NRO Staff Concerns About USAPWR Chapter 19 Material on Level 2 PRA and Severe Accident Evaluation

Office of New Reactors
February 2009

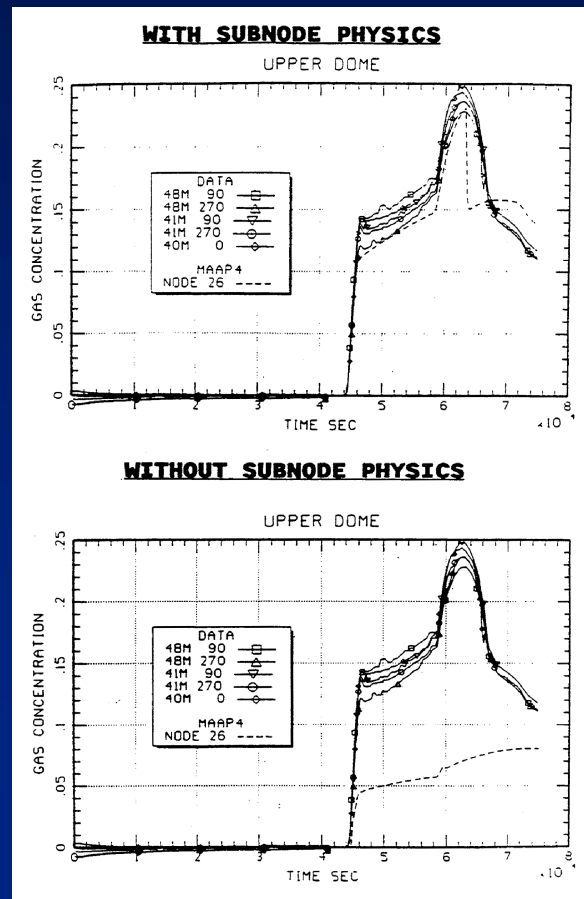
- The technical bases for some of the Level-2 PRA assumptions are not always fully stipulated or justified.
 - It is stated that hydrogen release behavior under hot leg creep-rupture conditions is the same as for LOCA events. Why?
 - It is stated that hydrogen does not accumulate under SGTR accident. What about under SBO-induced SGTR accident?
 - Even though creep rupture of RCS is predicted in high-pressure accidents, the depressurization by blowdown through the point of rupture is not actually simulated. Why not?
 - Heat removal by natural convection to fan heat exchangers is assumed to be the same as fan forced operation. Why and on what basis?
